Docket Number:	16-BSTD-06
Project Title:	Updates to the 2019 Time Dependent Valuation of Energy
TN #:	211716
Document Title:	Comments on the 2019 Title 24 Draft Time Dependent Valuation of Energy Updates
Description:	N/A
Filer:	Sabrina Savala
Organization:	Natural Resources Defense Council (NRDC)
Submitter Role:	Public Agency
Submission Date:	6/3/2016 1:01:26 PM
Docketed Date:	6/3/2016

NRDC Comments on the 2019 Title 24 Draft Time Dependent Valuation of Energy Updates
Docket #16-BSTD-06
June 3, 2016

Figure 1: Ratio of 2019 proposed electricity TDV values compared to gas TDV values.

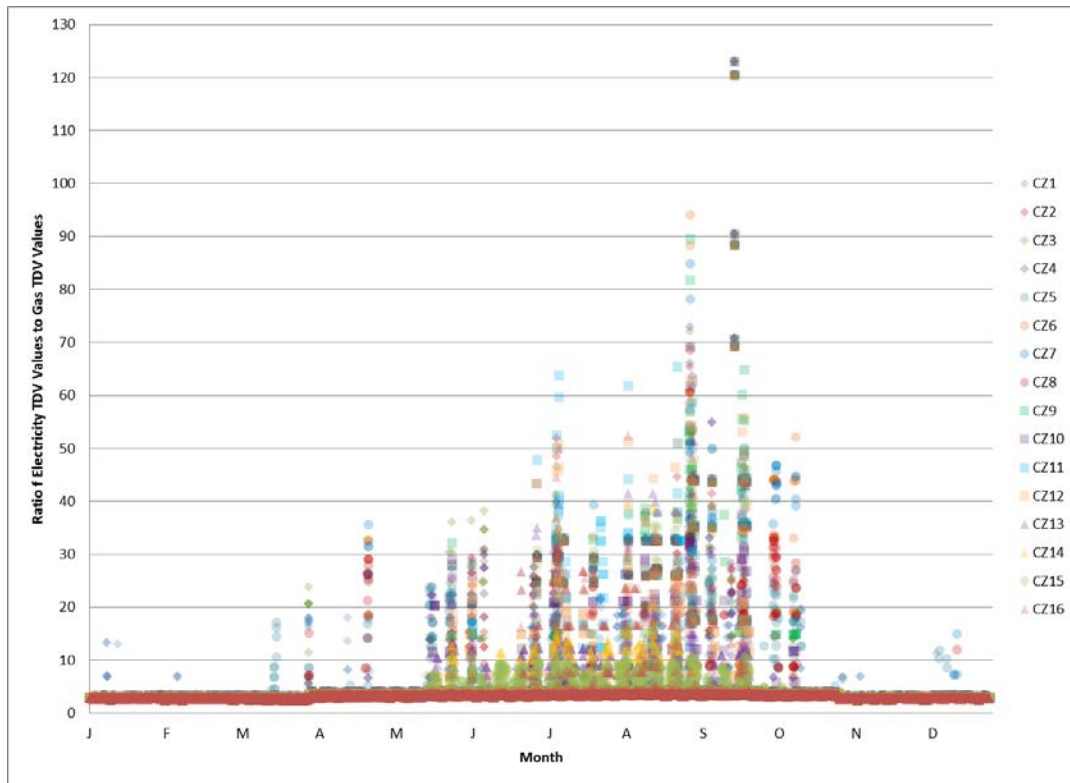
The result is TDV values for electricity that are much higher than for those of gas, primarily driven by the difference in retail rates. Across all climate zones, on average the electricity TDV values are 3.8 times those of gas. Even at the lowest cost hour for electricity, the TDV value of electricity is still 2.3 times more costly than that of gas (occurs in climate zone 16). And in the highest cost hour, the TDV value for electricity is 123 times that of gas (occurs in climate zone 4). Figure 1 shows how the levelized TDV values for electricity and gas compare across the 16 climate zones over the course of the year.³ As can be seen from the chart, generally the electric TDV values are about 3-4 times that of gas. For many hours of the year the difference is even greater, with these peak differences concentrated in the summer and fall

months. The large differences in electric and gas TDV values persist across all of California’s climate zones.

Figure 2: Comparison of average annual emissions and TDV energy use for water heating in a prototype home modeled CBECC-Res 2013.

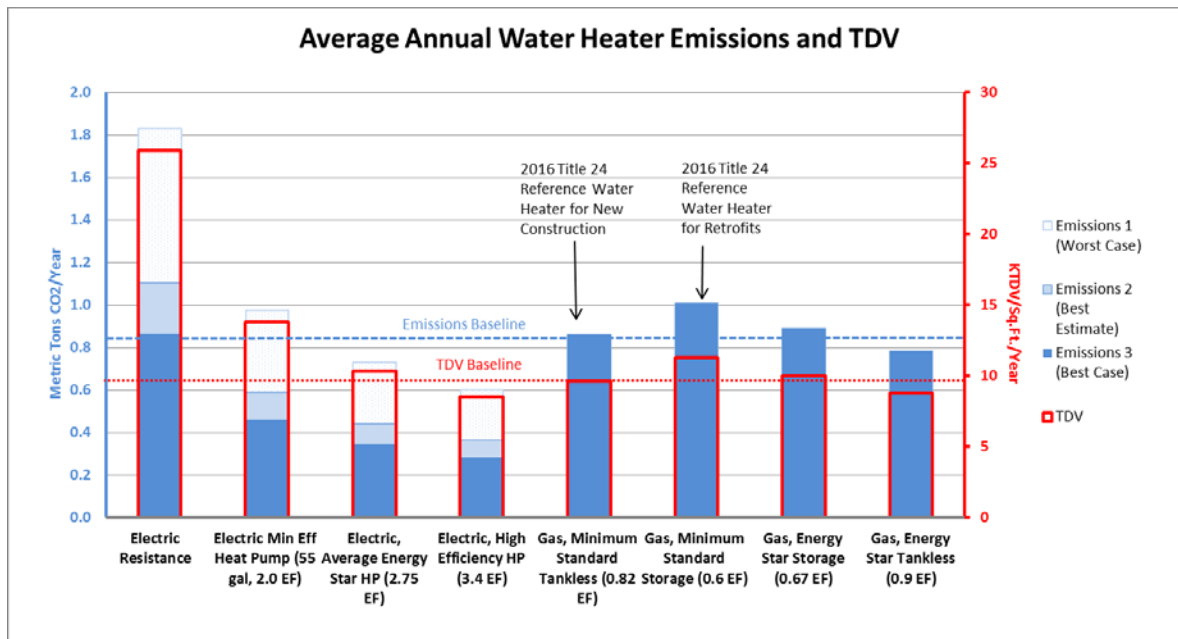
This large difference in electricity and gas TDV rates is significant because gas is used as the baseline fuel in many instances in the Title 24 Building Energy Standards. This is an issue for residential water heating in both new construction and retrofits, as well as space heating in retrofits. Figure 2 illustrates this issue. Figure 2 shows the average annual emissions and TDV energy use from water heating use in a prototype home modelled in CBEC-Res 2013 in five California climate zones. The emissions scenarios considered are described in detail in Appendix A. As can be seen from the chart, while only the most efficient heat pump available beats the TDV baseline set by a tankless gas water heater, all heat pump water heaters have lower emissions under the “best estimate” emissions scenario.

In summary, the TDV methodology should be changed to better reflect the full cost of achieving 80 percent emissions reductions by 2050. Incorporating these costs would be consistent with California’s policy and more realistically account for the full cost of achieving emissions reductions. *If the CEC is unable to modify the TDV values to reflect this full cost, the CEC should address this issue by using the same fuel type in the reference home as in the proposed design.* This would mean that homes using gas appliances would be compared to a gas home baseline and homes using electric appliances would be compared to an electric baseline. For water heating, we recommend using a minimum standard 55 gallon electric water heater as the baseline for homes that use electric water heating.

Figure 3: Average daily profile of emissions cost component of residential electricity TDV values in Climate Zone 12.

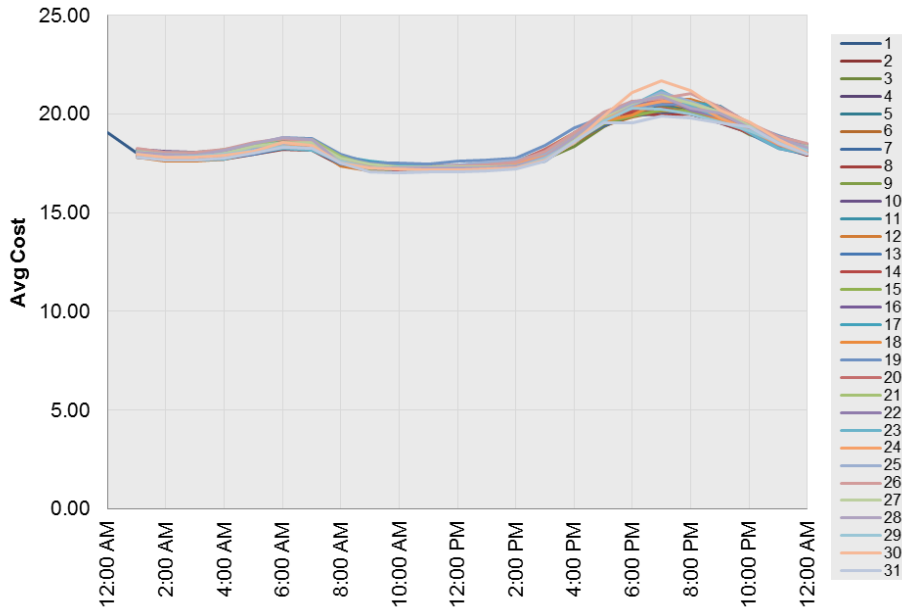
CEC should ensure that the emissions values used for the electricity TDV values accurately reflect the daily profile of resources likely over the next 30 years. Figure 3 shows the average daily profile of

the emissions cost adder for Climate Zone 12.⁴ While there is a dip in the cost per kilowatt-hour derived from emissions between 8 and 3 PM, it is small and does not appear to reflect the share of resources operating during these hours over the next 30 years that will be zero emission resources. The CEC should evaluate whether the emissions component of the electricity TDV values adequately reflect the share of zero emissions resources in the resource mix for each hour of the day over the next 30 years.
